CODE COMPLIANCE CERTIFICATE Section 43(3), Building Act 1991

Project Descrn: NEW CONSTRUCTION
BEING STAGE 1 OF AN INTENDED 1 STAGES
SHOWHOME/DWELLING (ON LOT 6)

Project Location: 52 KAKARIKI GR WAIKANAE

GENERAL FLOOR PLAN

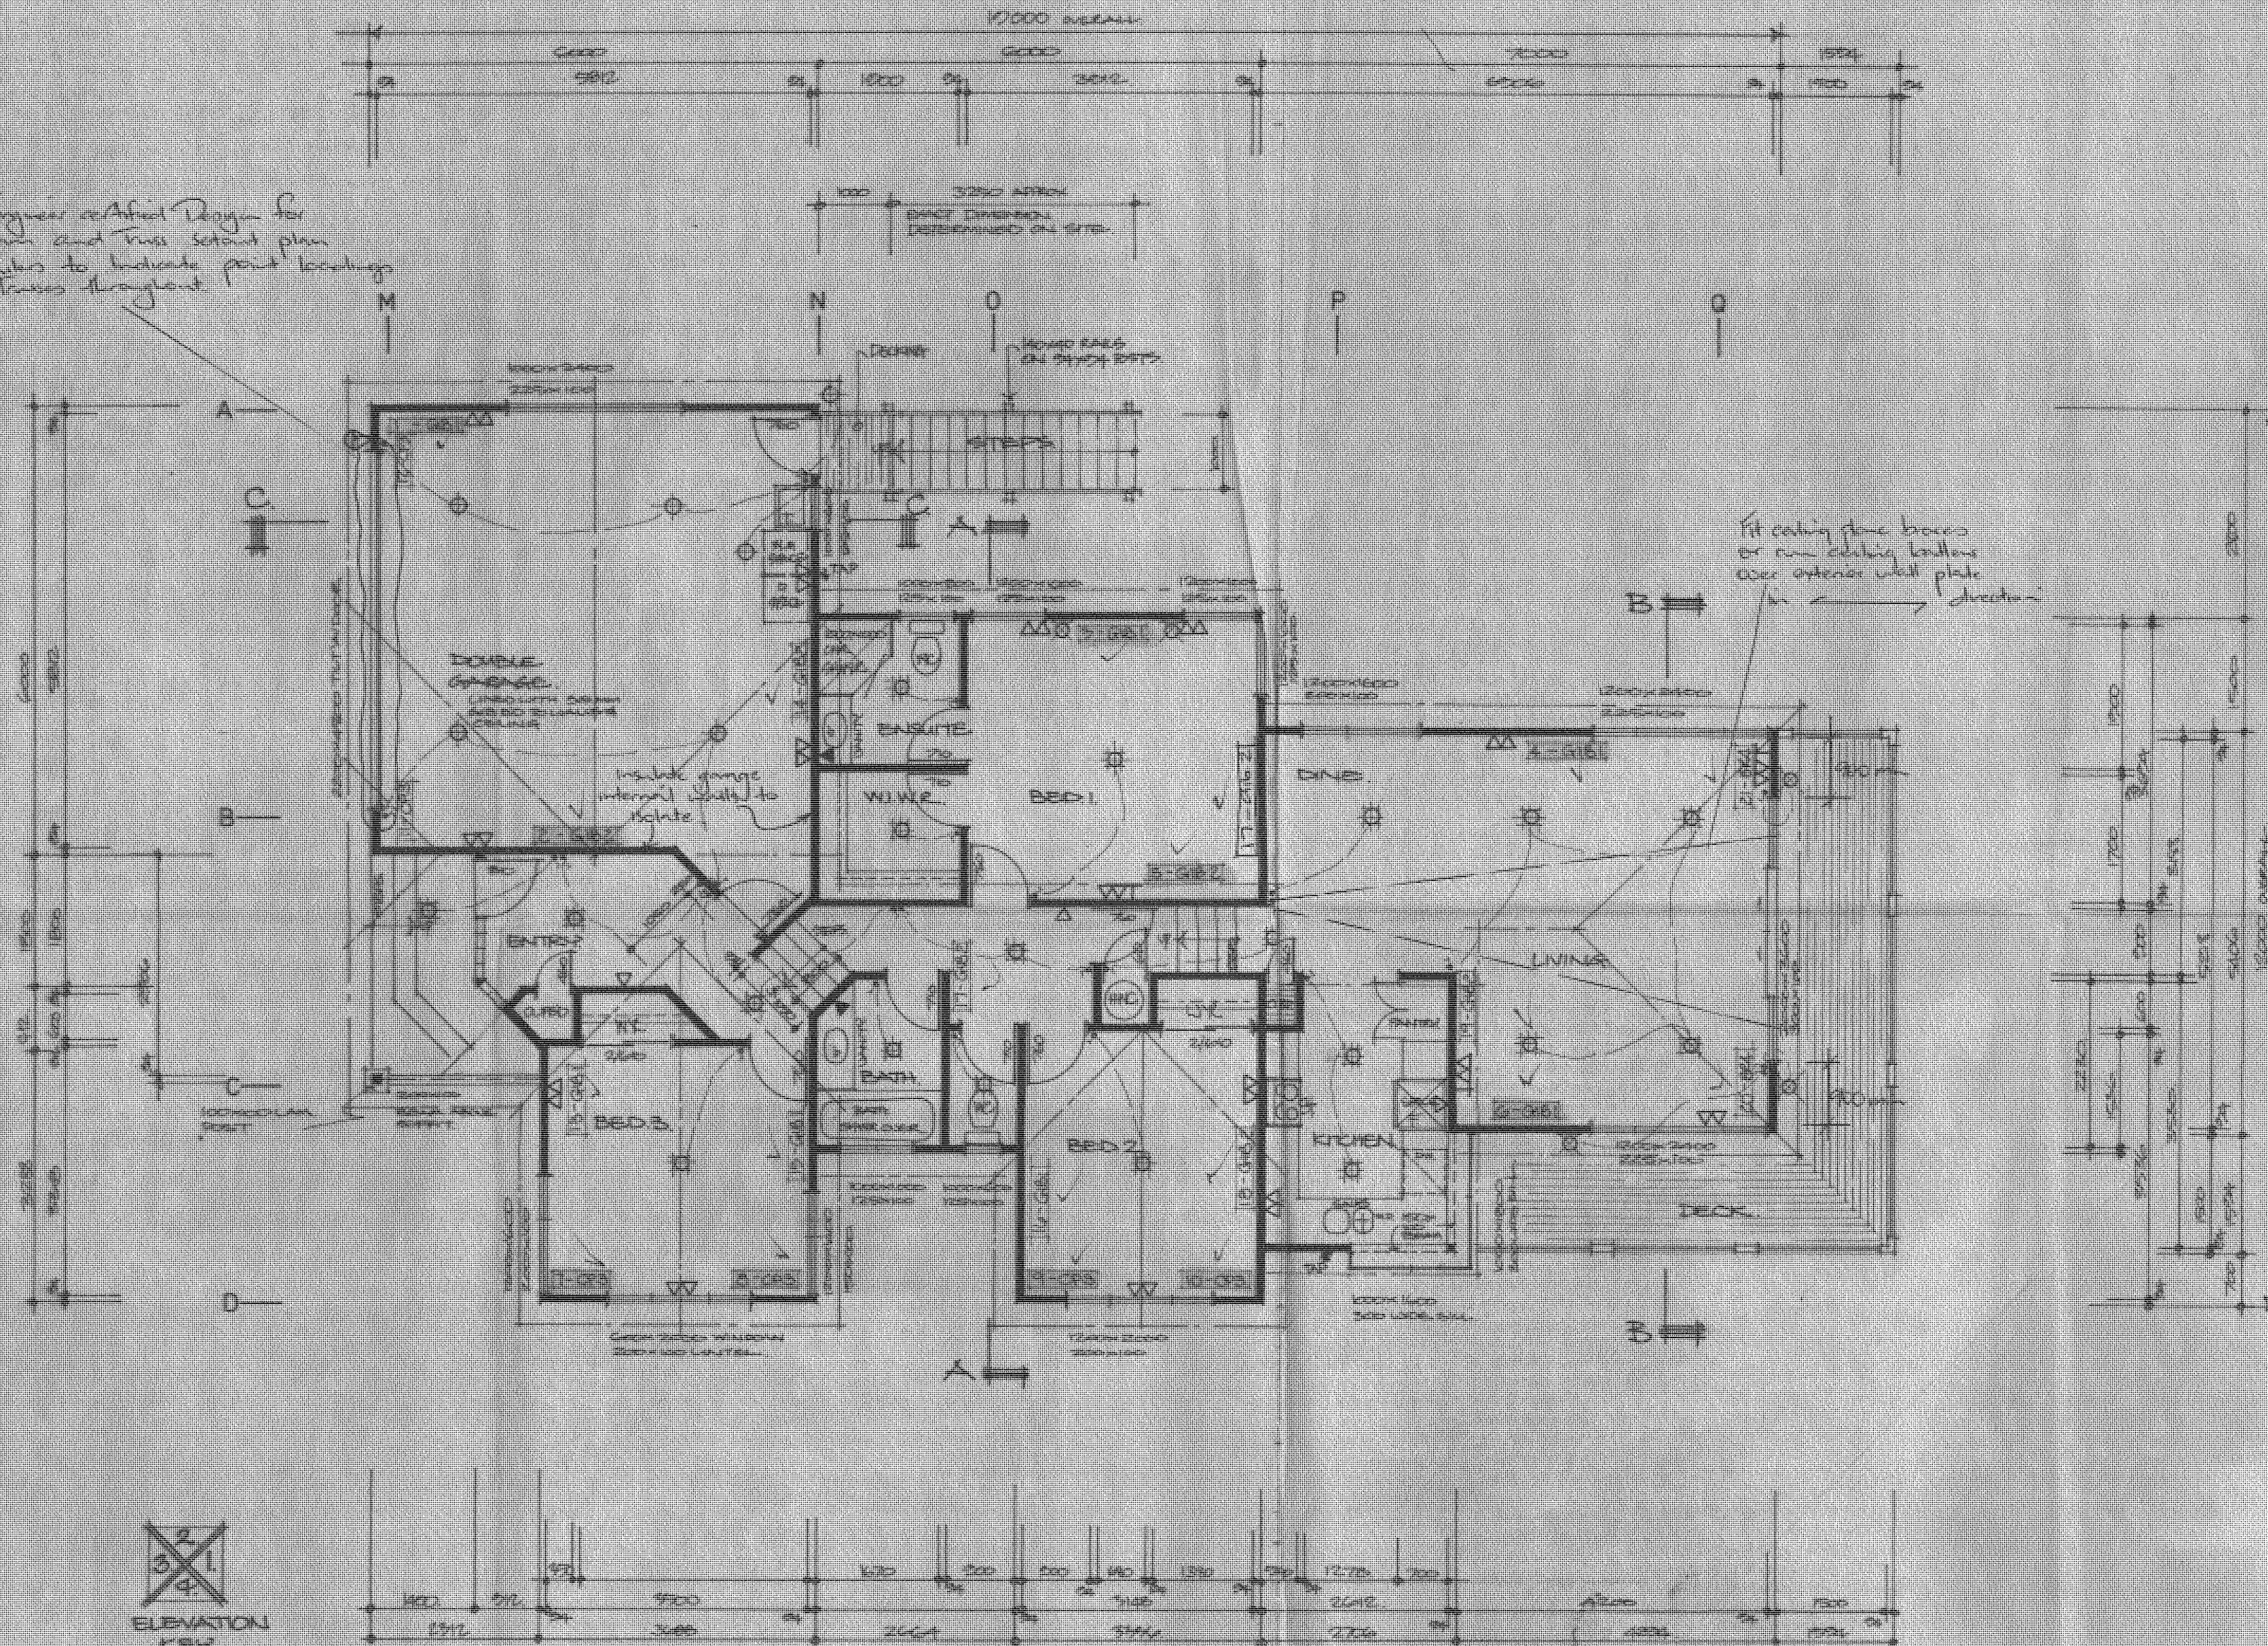
Provide Engineer certified Design for
 Paving, Benches and this set out plan
 from Perimeter to indicate point locations
 of under drains throughout

ELEVATION THREE
SCALE 1:100

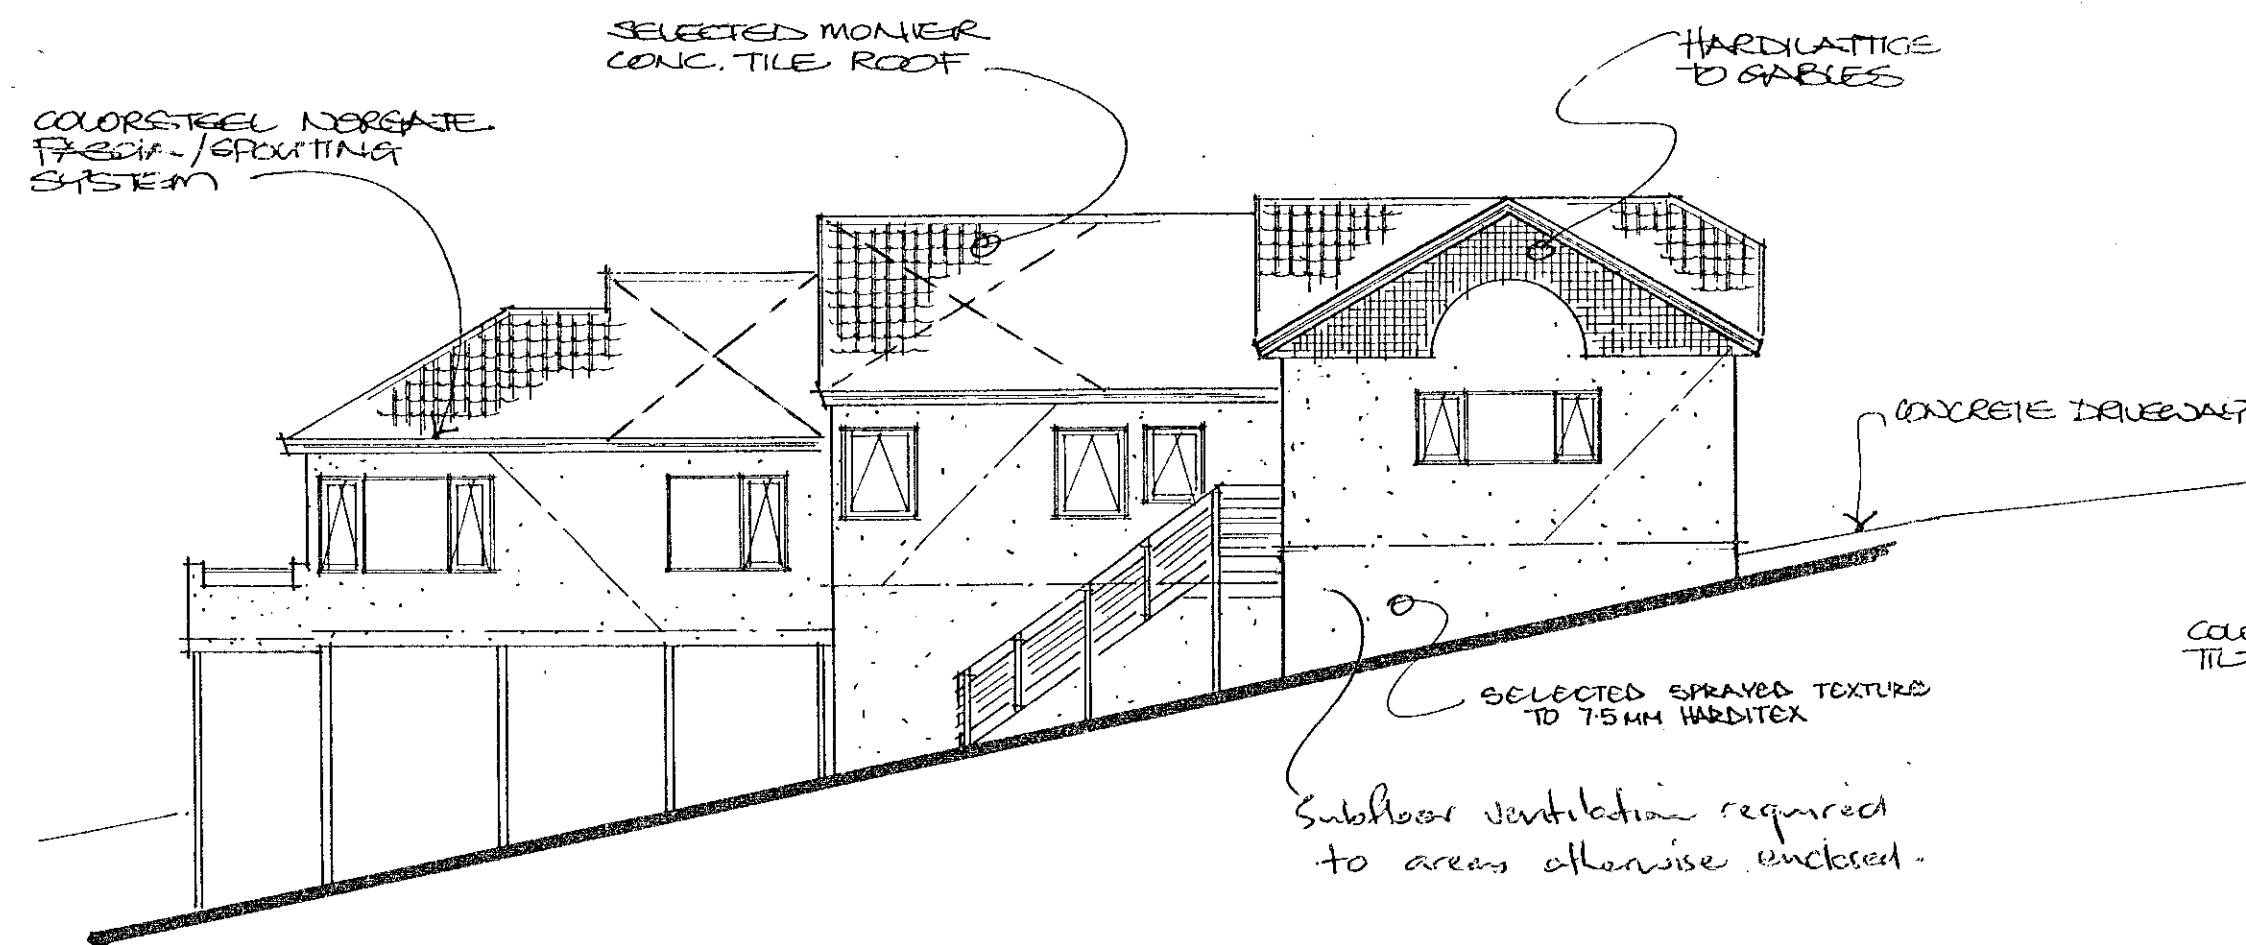
Roof bracing to NZS 3604:1990
Note also Roof Space bracing
requirements for Heavy Gabled Roofs
and conform.

ELEVATION FOUR
SCALE 1:100

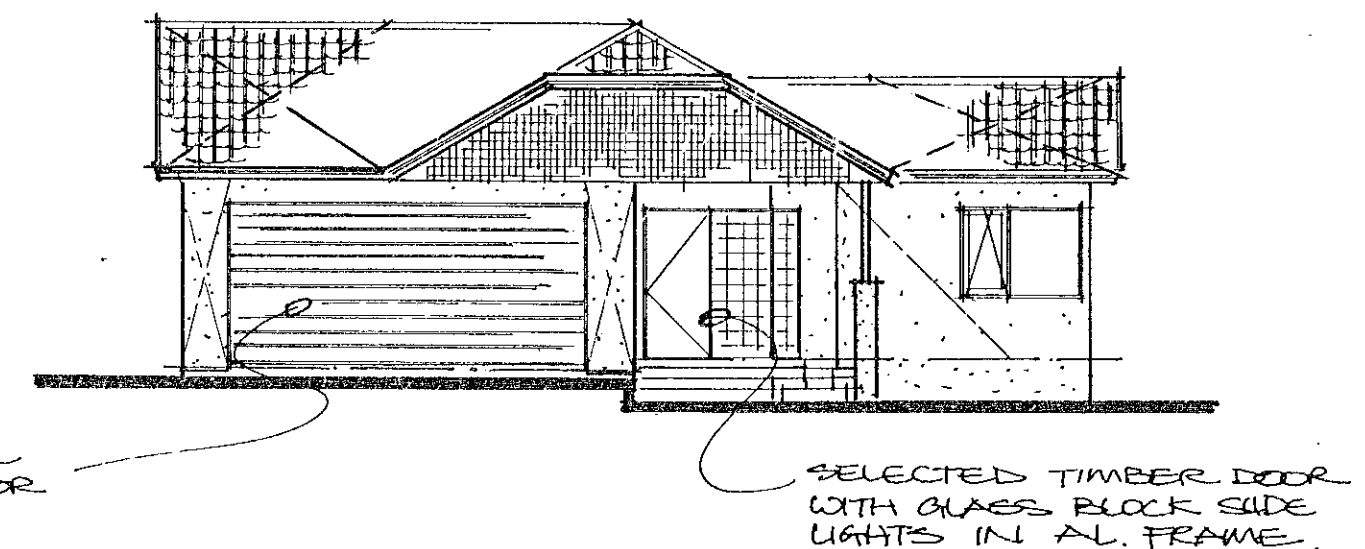
Fit suitable head flashings to exterior
Jambing.
Sealant only is not acceptable.

SECTION A-A SCALE 1:50

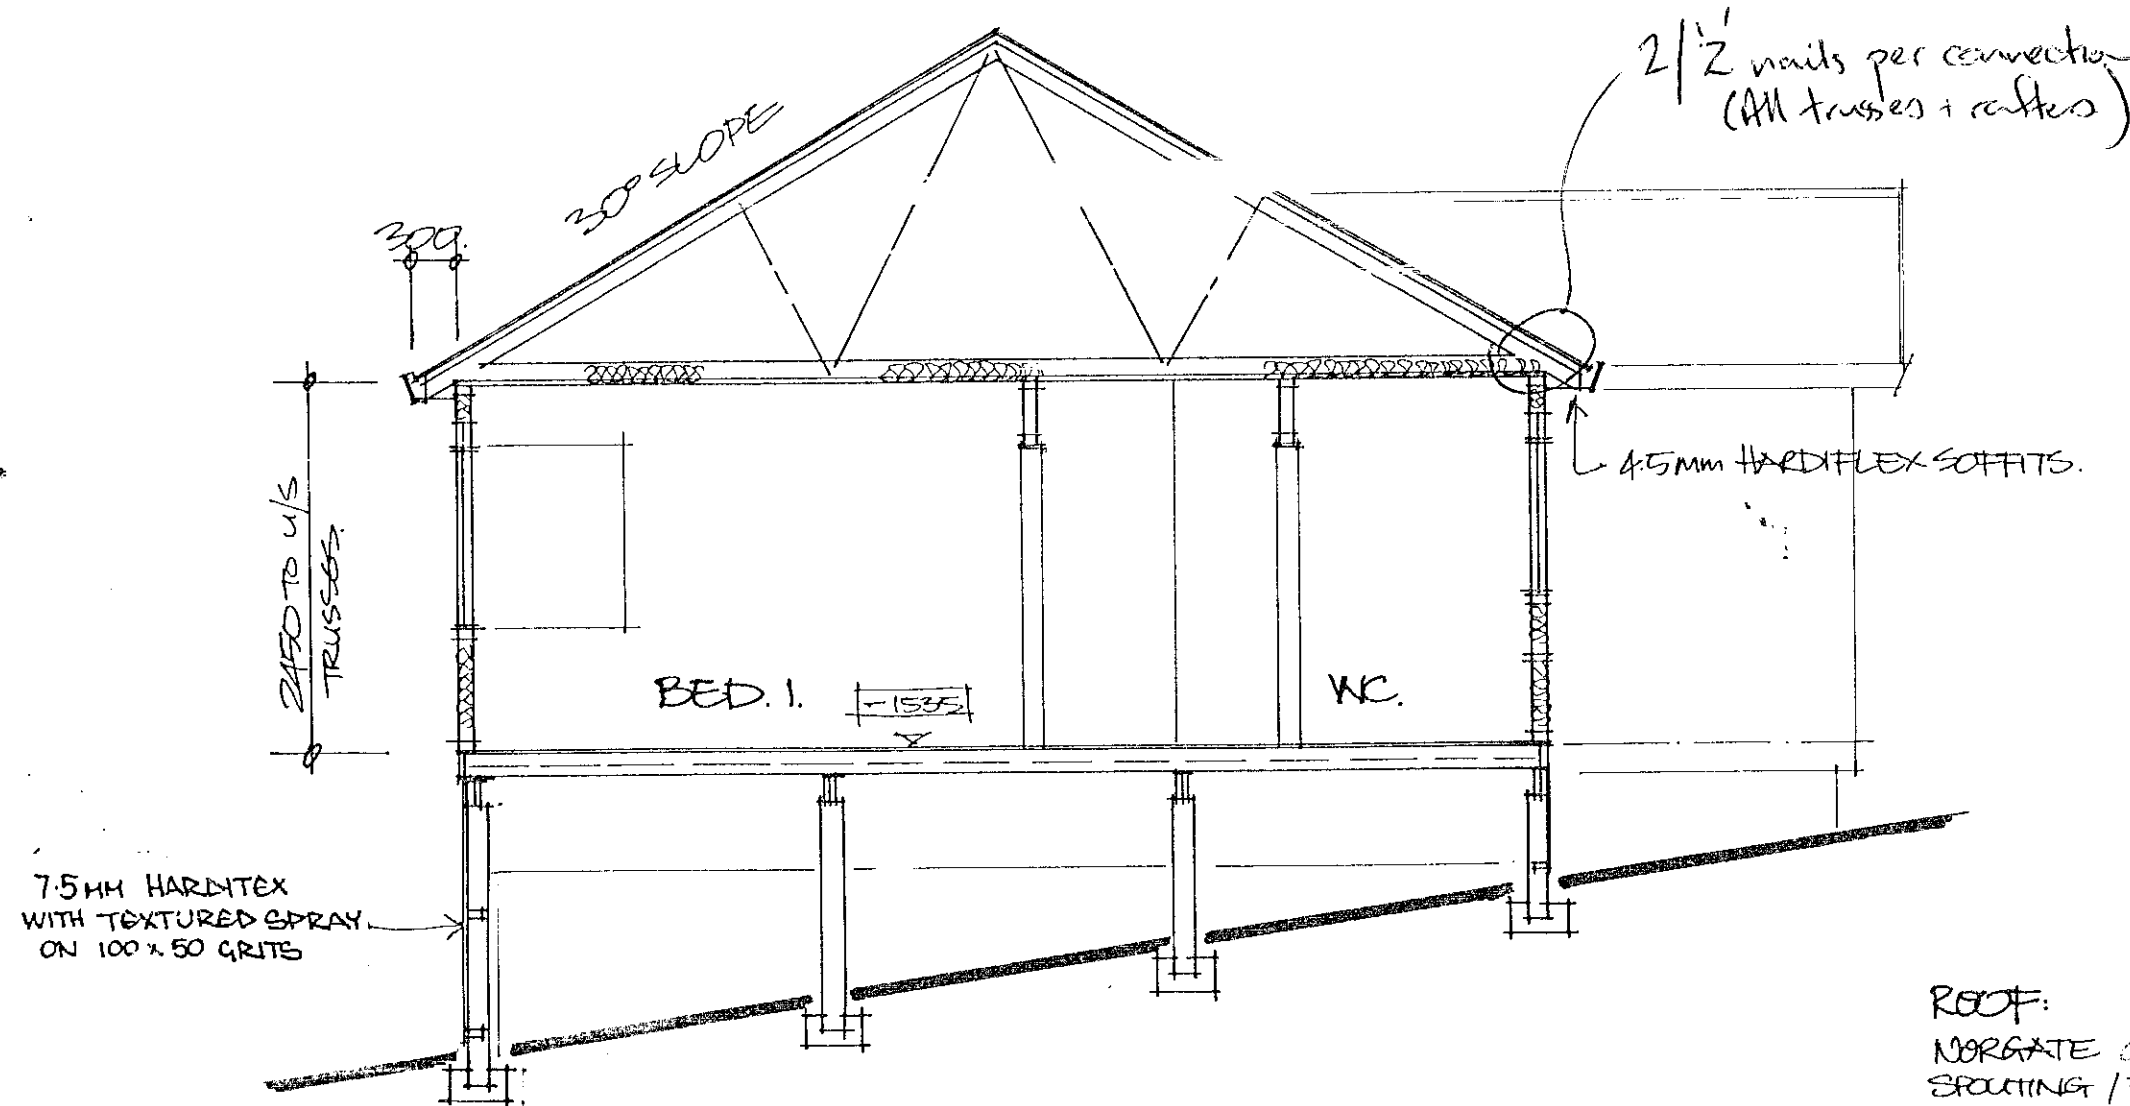
Diagonal Braces
 up to 3.0m long 100x75.
 3.0m - 4.5m. 2/100x50s
 or 100x100.
